STATE OF WASHINGTON  
DEPARTMENT OF FISH AND WILDLIFE

5 September, 2000

Subject: Comments on the *Proposed Plan for the 300-FF-2 Operable Unit* DOE/RL-99-53, Rev. 0, and the *Focused Feasibility Study for the 300-FF-2 Operable Unit*, DOE/RL-99-40, Rev. 0.

Well 399-2-2

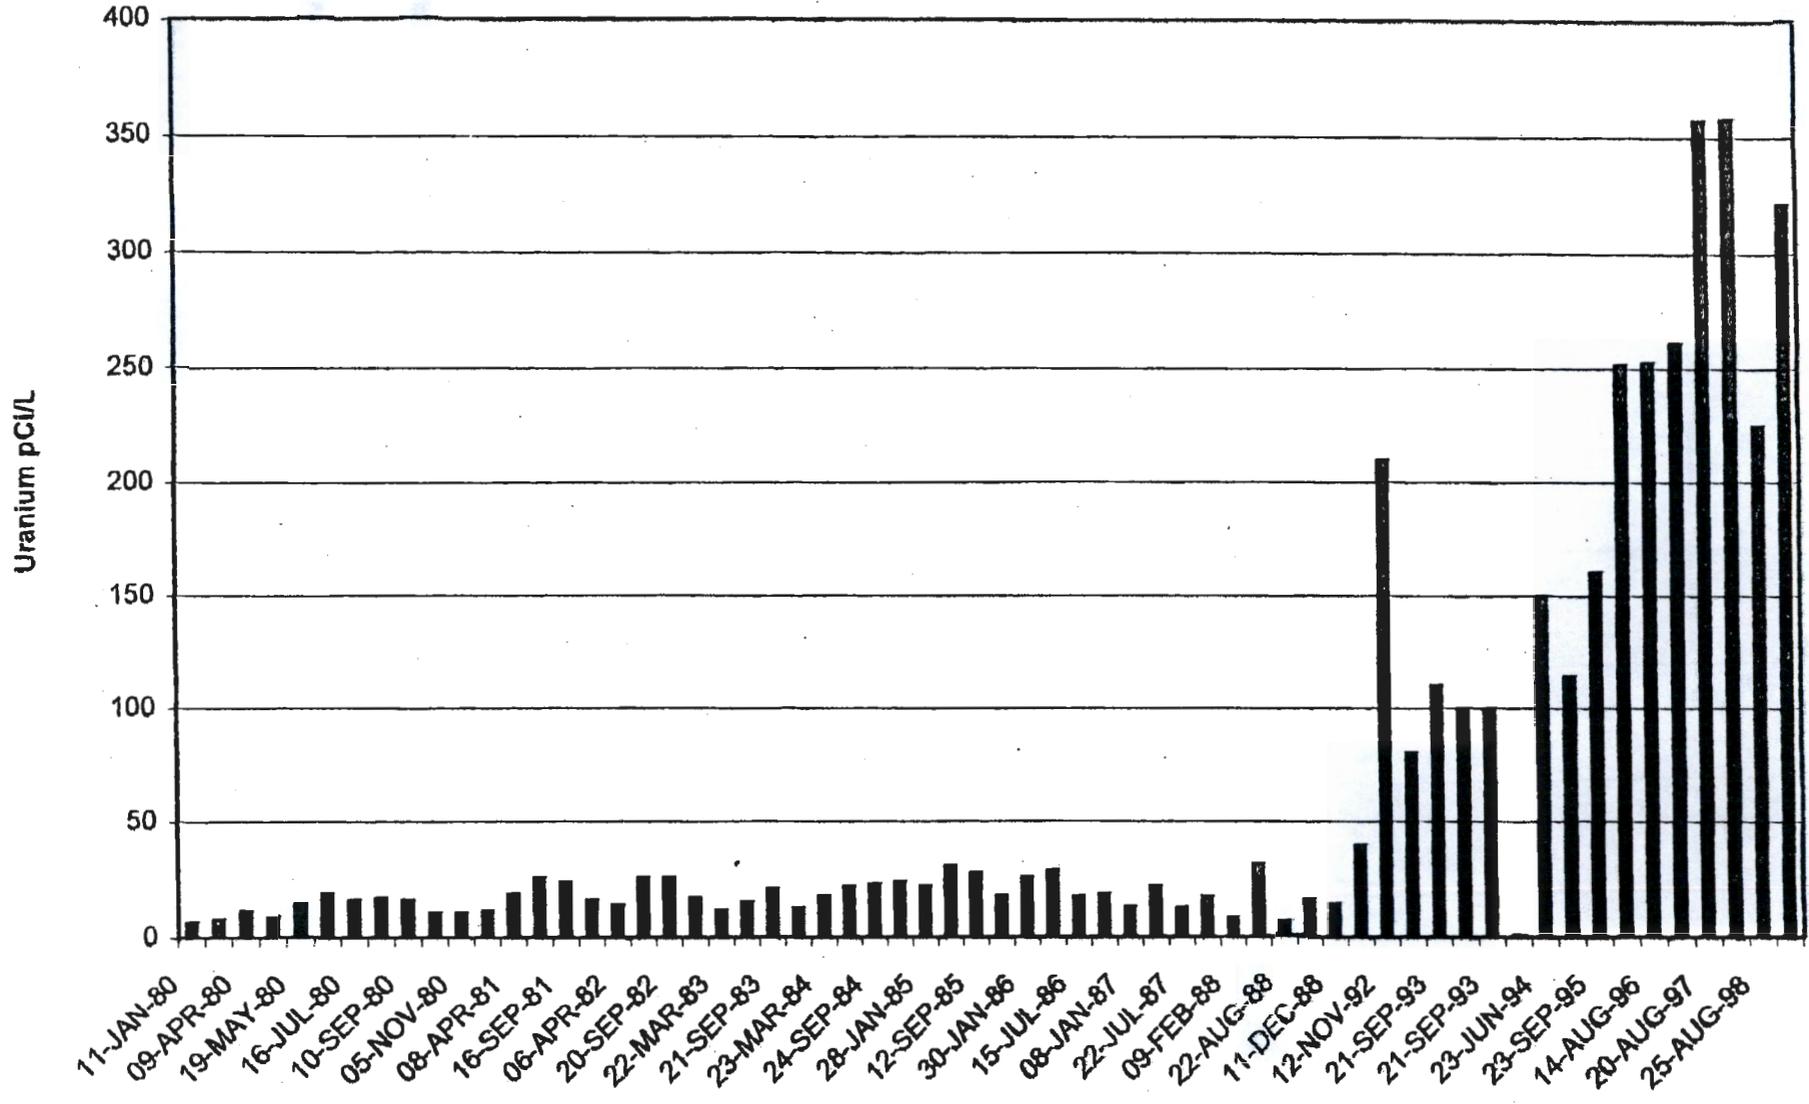
- Uranium concentrations have not decreased as predicted. See plots from wells 399-2-3, 399-2-2, 399-1-5, 399-1-4, 399-3-10, 399-2-1, 399-1-2, 399-3-3, 399-3-2, and 399-3-6.

- Wells 399-2-2, 399-2-3, 399-3-1, 399-3-9 and 399-3-10 are located north to south along the river shoreline. The trend plots show gradual increasing uranium concentrations in all these wells. The increasing trend is seen beginning around the year 1990 and has been increasing since. The maximum concentration of uranium in the north most well 399-2-2 is about 350 pCi/L and the southern well 399-3-10 is about 90 pCi/L. All these wells fall within the 300-FF-5 uranium plume. All these wells are very close to the river and it can be easily concluded that the contaminant has been polluting the river for many years.

Well 399-3-6

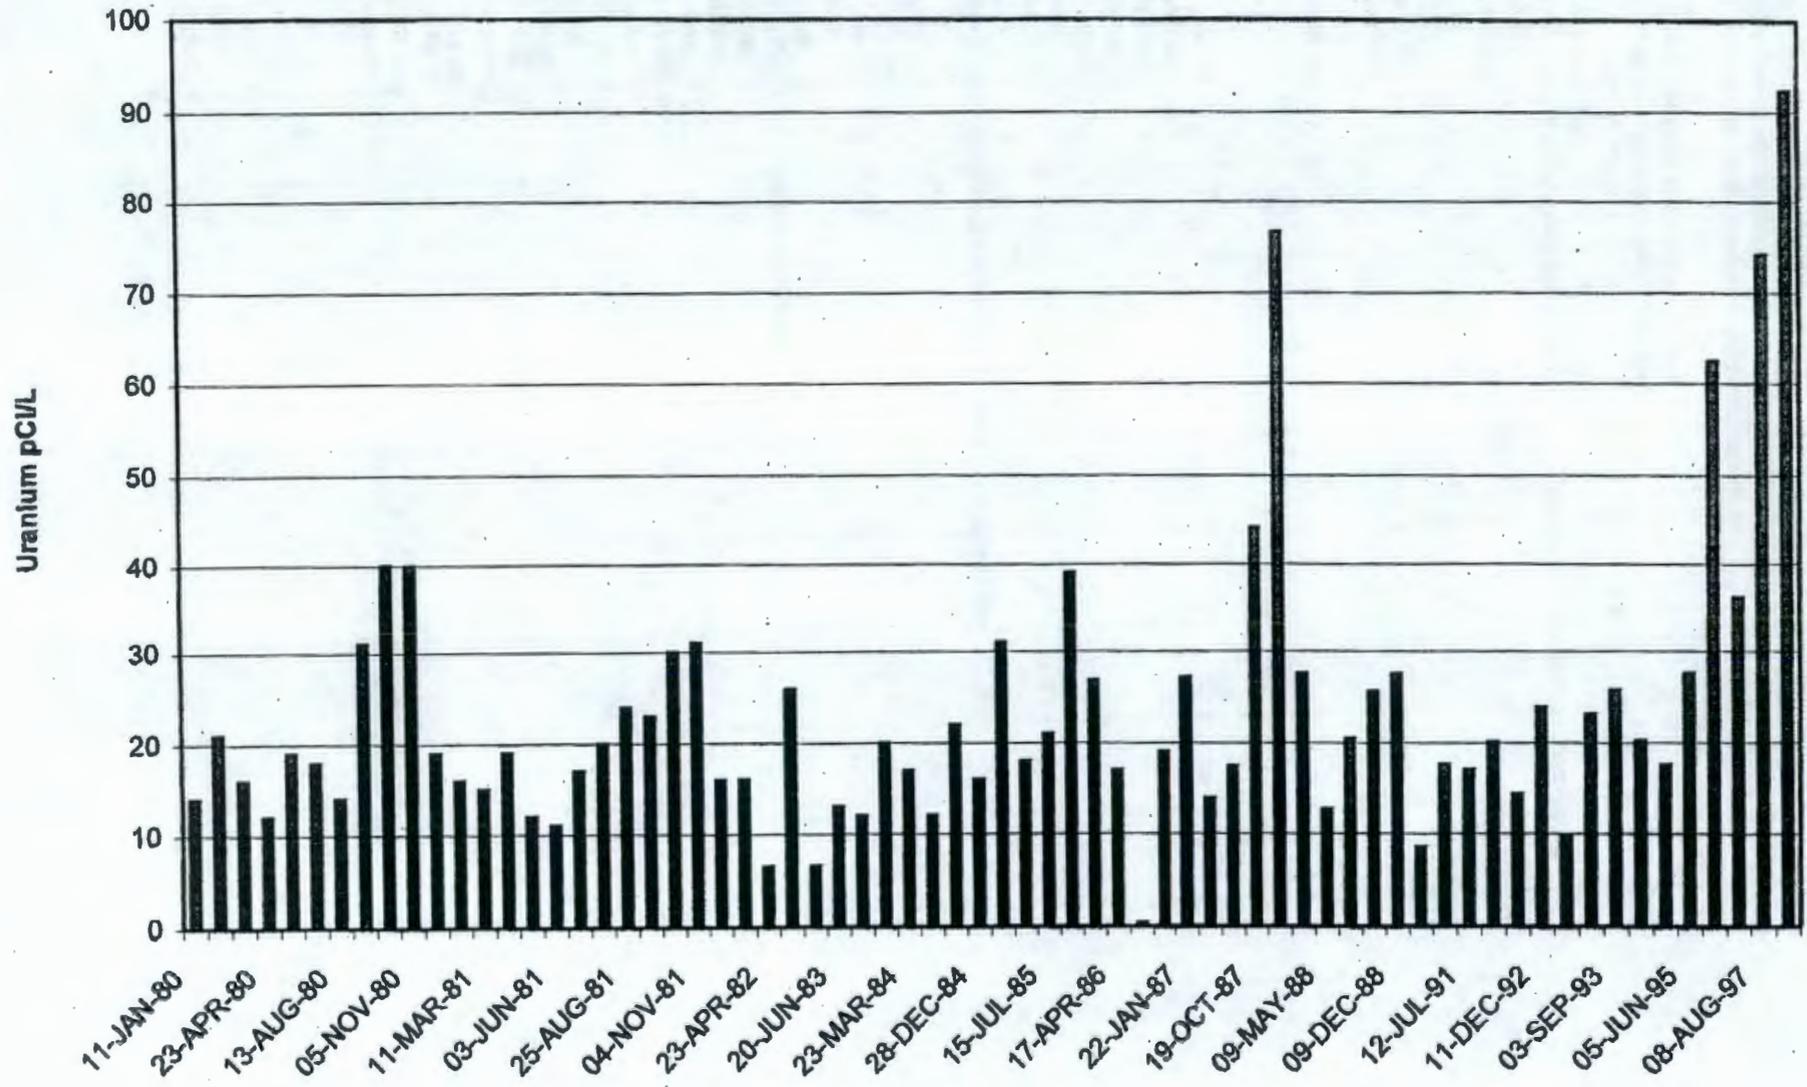
- Wells 399-3-6, 399-3-2 and 399-3-3 are located on the southern part of 300-FF-1 area and are outside the boundary of the uranium plume. There is no specific trend of the uranium concentrations on these wells. However, the concentrations of uranium have been periodically up to approximately 40 pCi/L. Some external source seems to be impacting the uranium concentrations of these wells.

Well 399-1-2

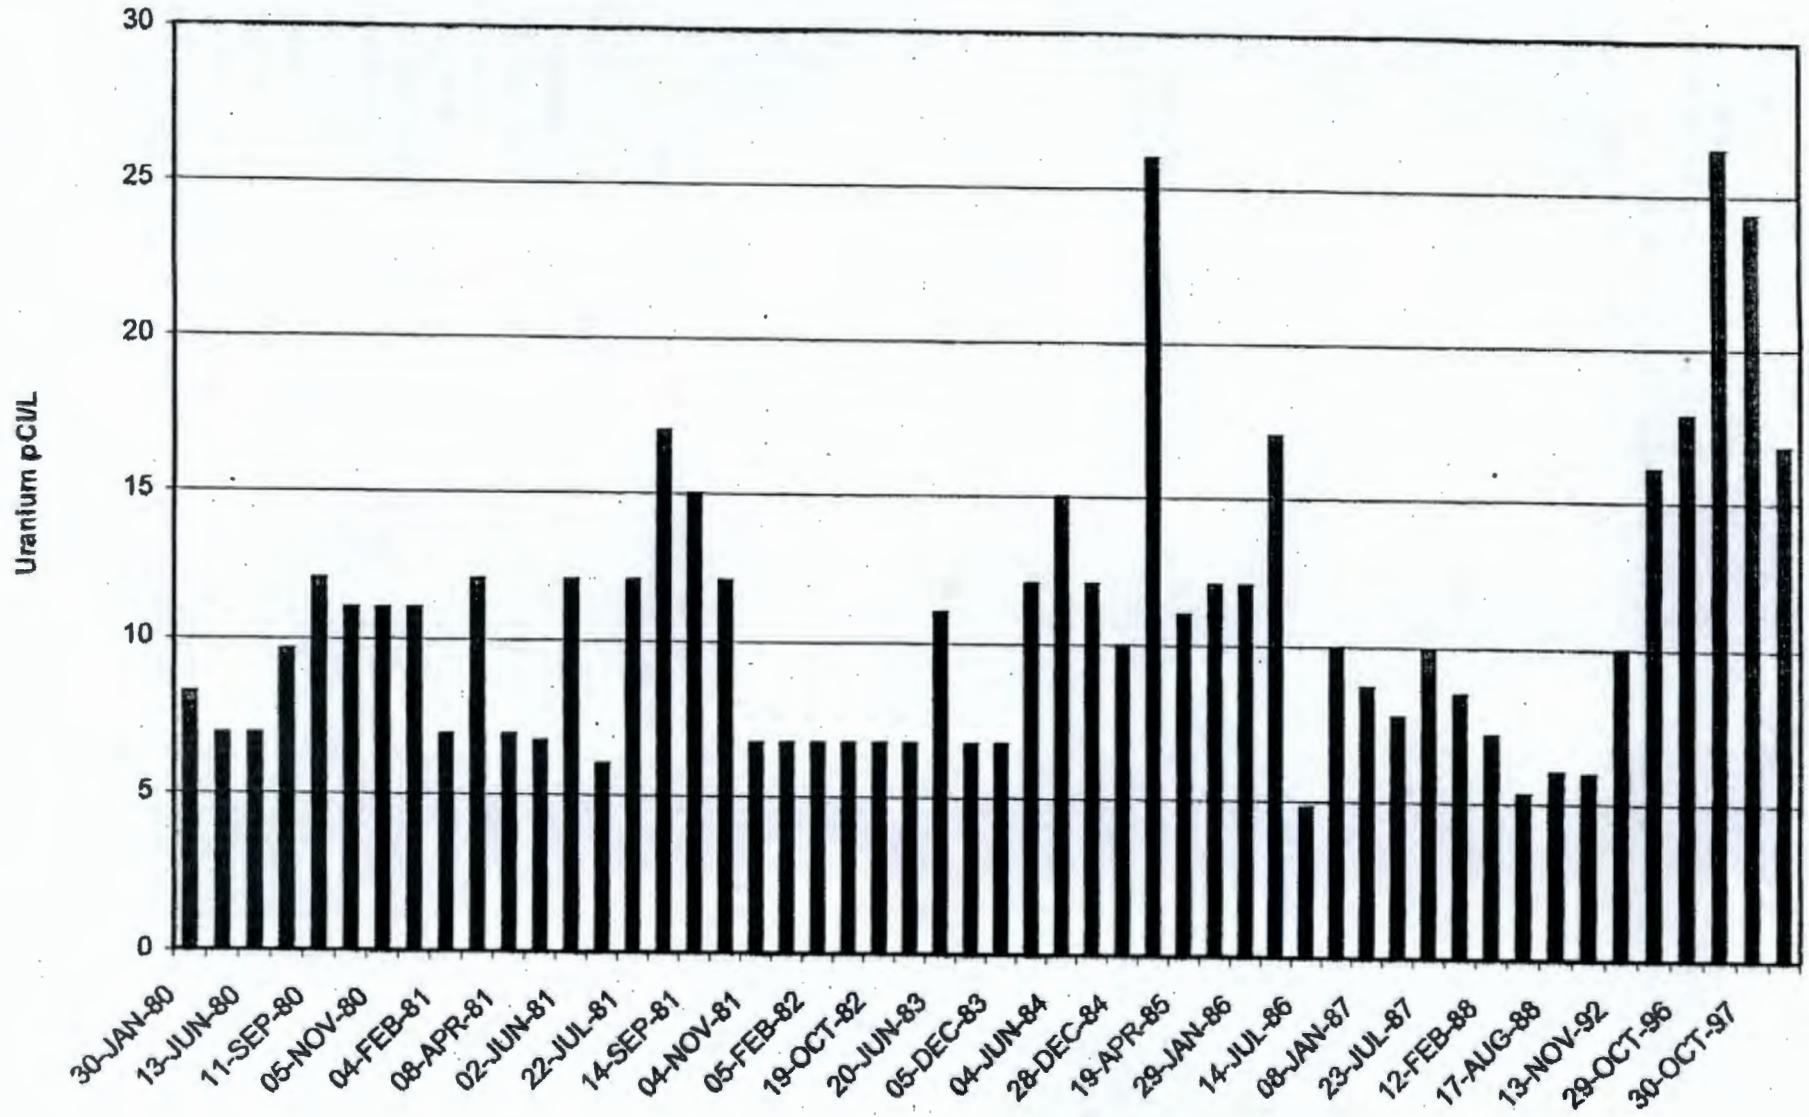
- Wells 399-1-2, 399-1-4 and 399-1-5 have also been plotted for uranium trends. These wells are located within uranium plume and are on the western edged of 300-FF-1 operable unit. Well 399-1-5 shows a definite increasing trend of uranium since about 1992, the maximum concentration being about 180 pCi/L. The other two wells, 399-1-2 and 399-1-4, indicate concentrations in the range of 20 to 50 pCi/L since the beginning of observations. The impact on these wells could be from the source sites in the vicinity of the wells.
